Liveable Neighbourhoods Zone 04 - Lower Lansdown

Stage 1/2 Road Safety Audit
Response Report

Project number: 60668625

Appendix B – Location of Problems Plan

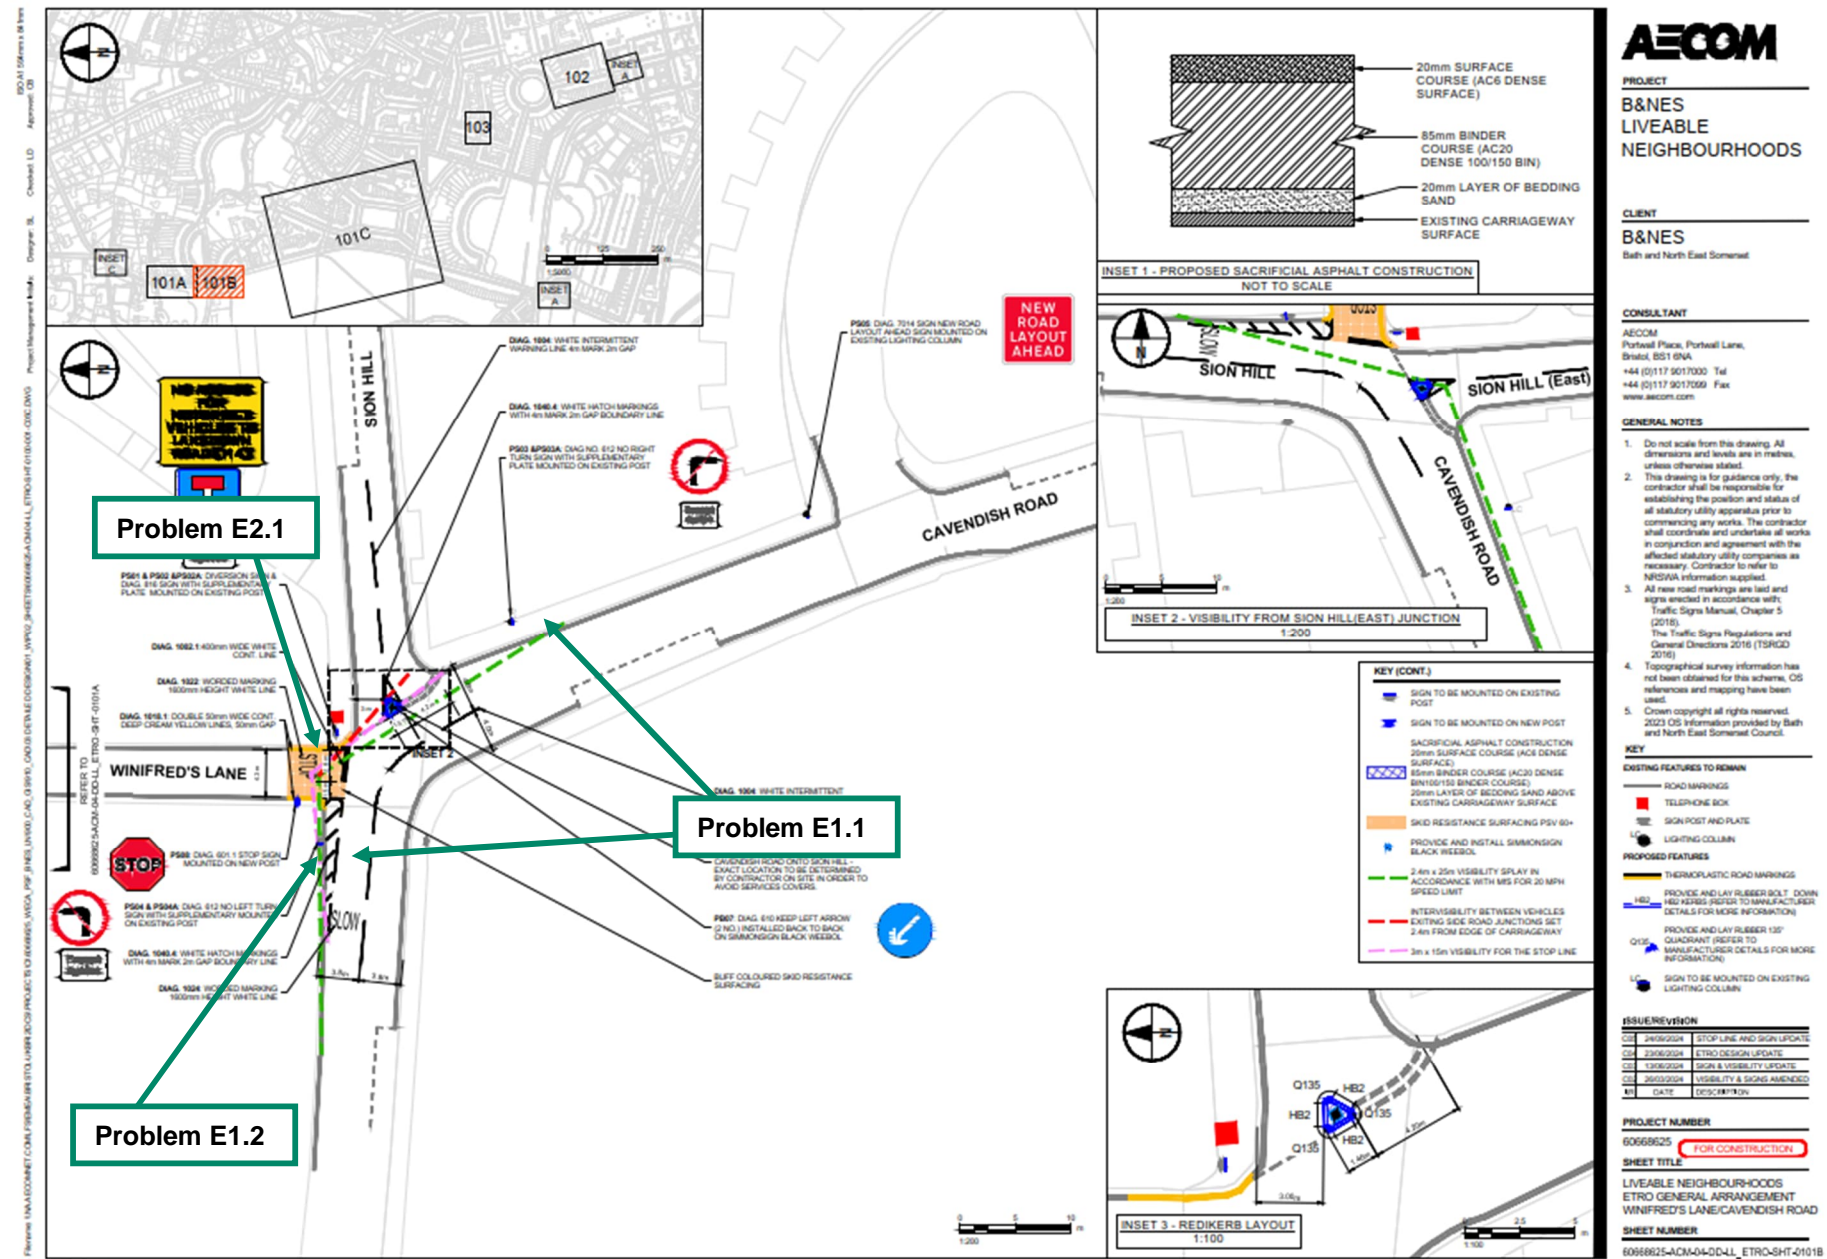
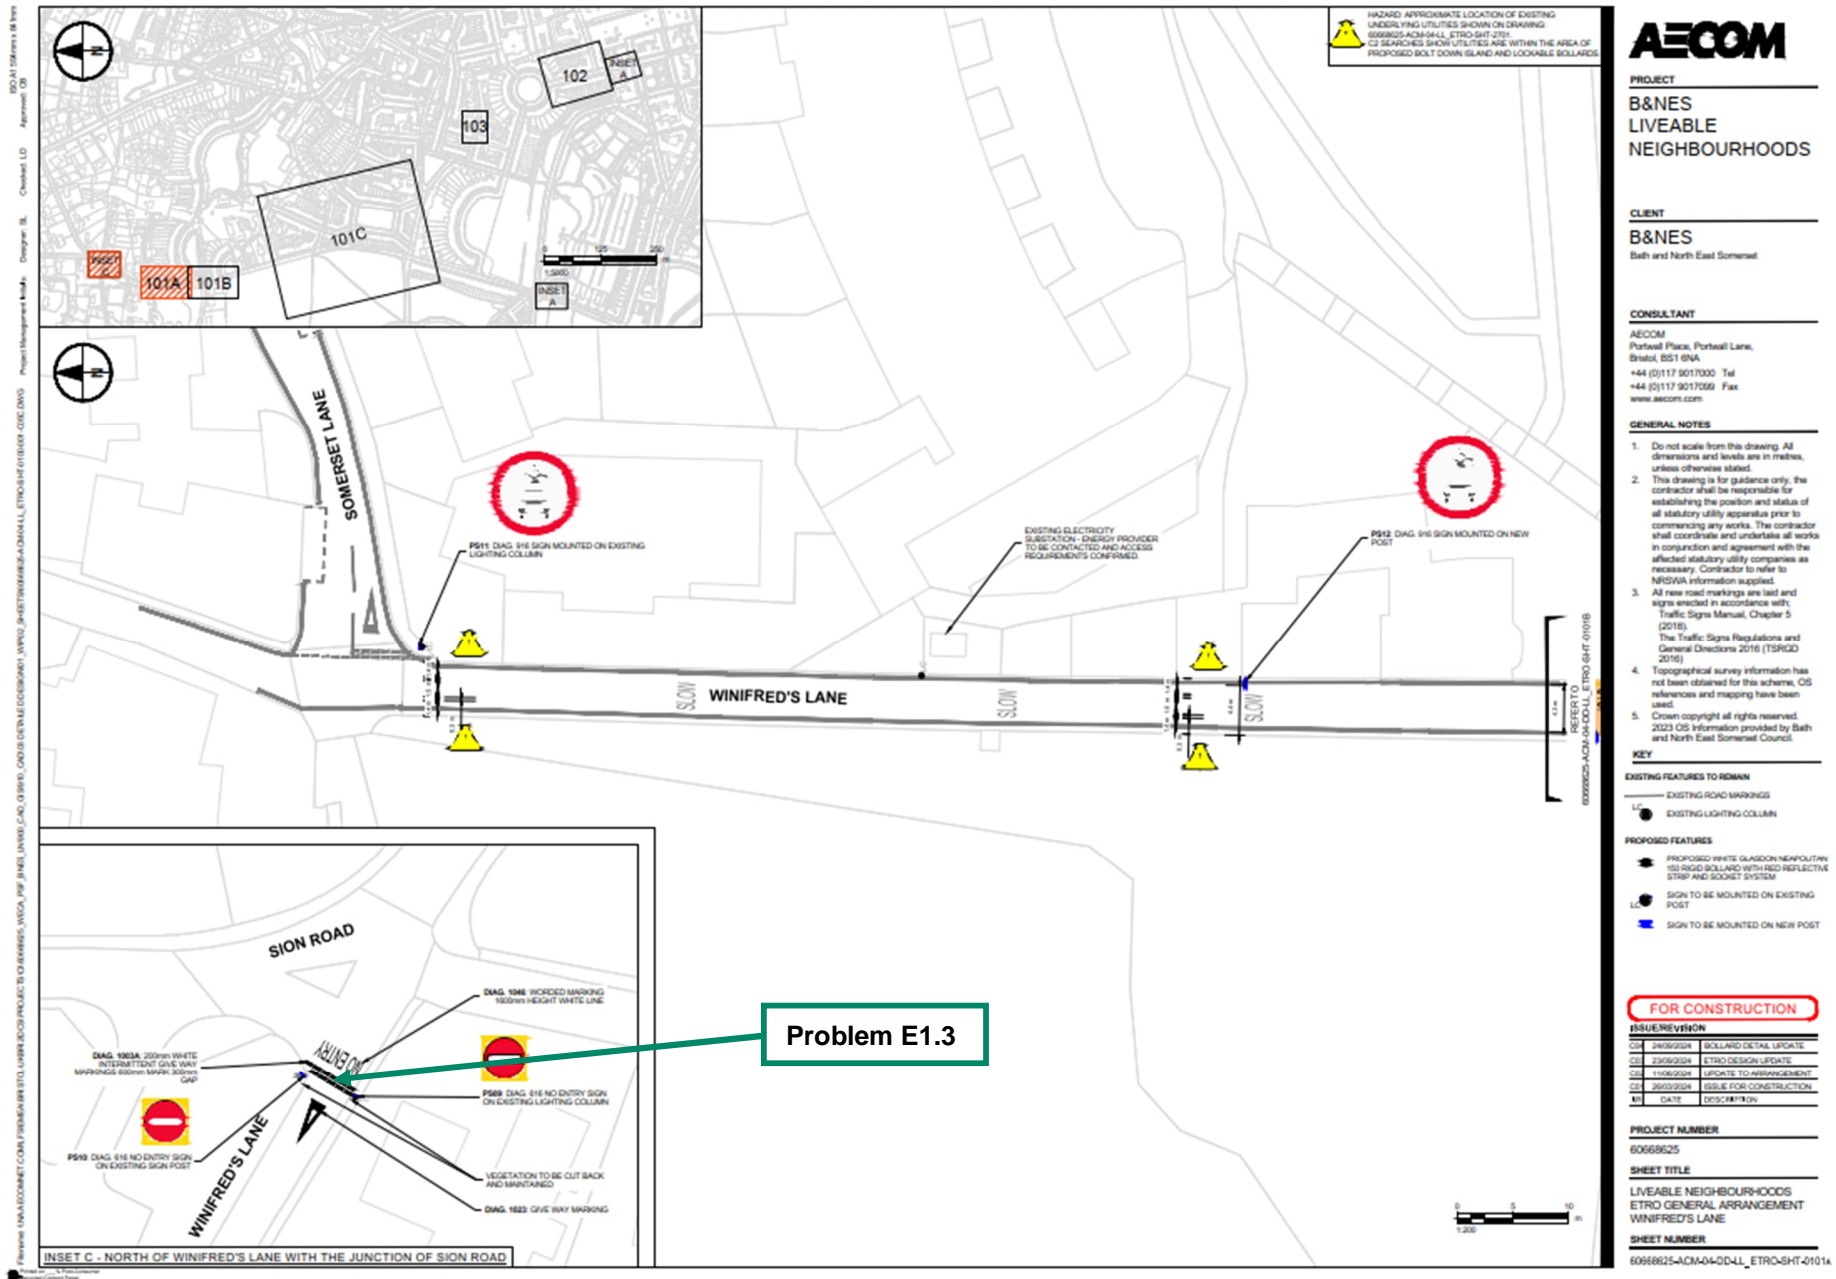
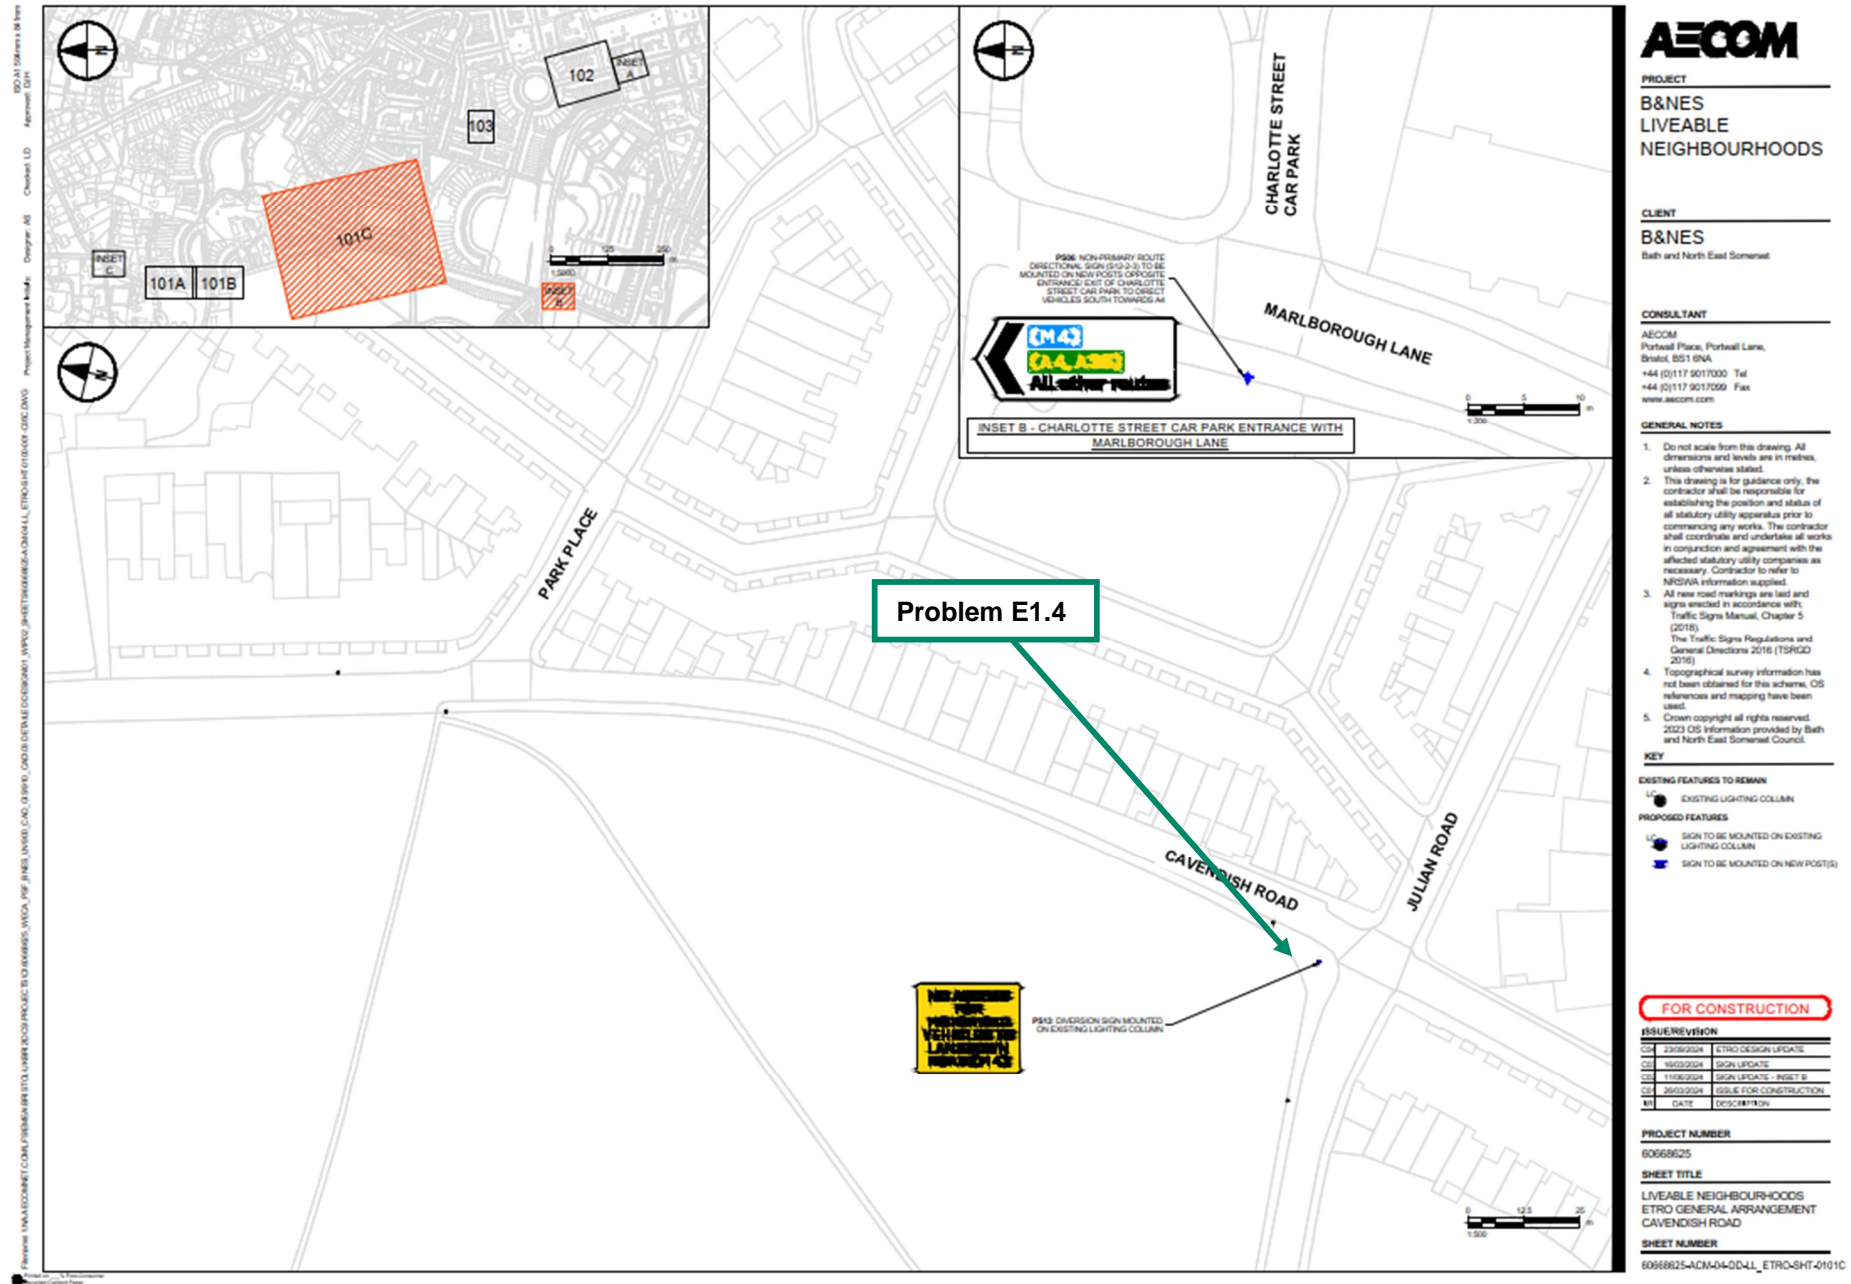
Problem: E1.2	
Drawing Number(s):	60668625-ACM-04-DD-LL_ETRO-SHT-0101B.
Location:	Winifred's Lane.
Summary:	Visibility for egressing vehicles from Winifred's Lane may be restricted due to existing vegetation, resulting in drivers pulling out into oncoming vehicles, causing a side swipe collision.
Description:

<p>The proposals change the priority on Winifred's Lane by introducing a stop line and giving priority to eastbound vehicles on Sion Hill; however, during the site visit the Audit Team observed vegetation overhanging the carriageway of Sion Hill. If the overhanging vegetation is not cut back and maintained, drivers approaching Sion Hill from Winifred's Lane may pull out into oncoming vehicles due to the obstructed visibility. This may result in side swipe or head on collisions.</p>	
Recommendation:	
It is recommended that a maintenance plan is put in place and the vegetation is cut back and maintained regularly.	
Designer Organisation Response:	
<p>Agree with the recommendation</p> <p>Regular maintenance will be undertaken to remove overgrown vegetation for the duration of the experimental order.</p>	
Overseeing Organisation Response:

Problem: E1.4	
Drawing Number(s):	60668625-ACM-04-DD-LL_ETRO-SHT-0101C.
Location:	Weston Road.
Summary:	Lack of advanced warning sign for prohibited vehicle movements may result in vehicles undertaking sudden manoeuvres, resulting in rear end shunt or graze type collisions.
Description:

<p>The proposals prohibit vehicle access to Lansdown Road (and the M4) from Cavendish Road to reduce the amount of traffic utilising Sion Hill (east); however, vehicles approaching Cavendish Road from Weston Road are not provided with advanced warning of this restriction. This may result in vehicles undertaking sudden manoeuvres at the junction of Weston Road / Cavendish Road as they approach the proposed warning sign, causing rear end shunts or graze type collisions with other road users.</p>	
Recommendation:	
<p>It is recommended that an advanced warning sign is placed on Weston Road before the junction with Cavendish Road indicating to drivers that all routes are to be accessed along Julian Road.</p>	
Designer Organisation Response:	
<p>Partially agree with the recommendation</p> <p>The junction is a conservation area therefore sign clutter is to be kept at a minimum. Therefore, the text on the proposed sign will be amended to include the additional words 'USE JULIAN ROAD' at the end of the sentence.</p>

Problem: E2.1	
Drawing Number(s):	60668625-ACM-04-DD-LL_ETRO-SHT-0101B.
Location:	Winifred's Lane.
Summary:	Insufficient length of proposed high friction surfacing may result in loss of control type collisions due to differential skid resistance between the front and back wheels of a vehicle.
Description:	
<p>The proposals provide the use of high friction surfacing at the stop line of Winifred's Lane; however, the length of the high friction surfacing appears short. Vehicles approaching the stop line may have a differential skid resistance between their front and back wheels as they slow, resulting in a loss of control type collision which may cause personal injury to vehicle occupants or other road users.</p>	
Recommendation:	
It is recommended that the high friction surfacing is extended further north along Winifred's Lane.	
Designer Organisation Response:	
<p>Disagree with the recommendation</p> <p>The high friction surfacing is to be used as a visual aid to define the difference in road of Winifred Lane from the revised main route on Sion Hill. Only residents of the adjacent building and cyclists will use the junction, with both categories not likely to approach the junction at speed.</p>

That the CRSTS Liveable Neighbourhoods Project Manager will put in place a maintenance plan to remove overgrown vegetation for the duration of the experimental order.

Overseeing Organisation Response:	
<p>The Overseeing Organisation agrees with the Designer Organisation response.</p>	
Agreed RSA Action:	
<p>That the text on the proposed sign will be amended to include the additional words 'USE JULIAN ROAD' at the end of the sentence. To be actioned by the Design Organisation.</p>

Overseeing Organisation Response:	
<p>The Overseeing Organisation would note that the introduction of the anti-skid surfacing was primarily to provide additional anti-skid surfacing for cyclists as they approach the Stop Line. The Overseeing Organisation would therefore agree with the Designer Organisation response.</p>	
Agree RSA Action:	
To retain the high friction surfacing as shown on the drawing.
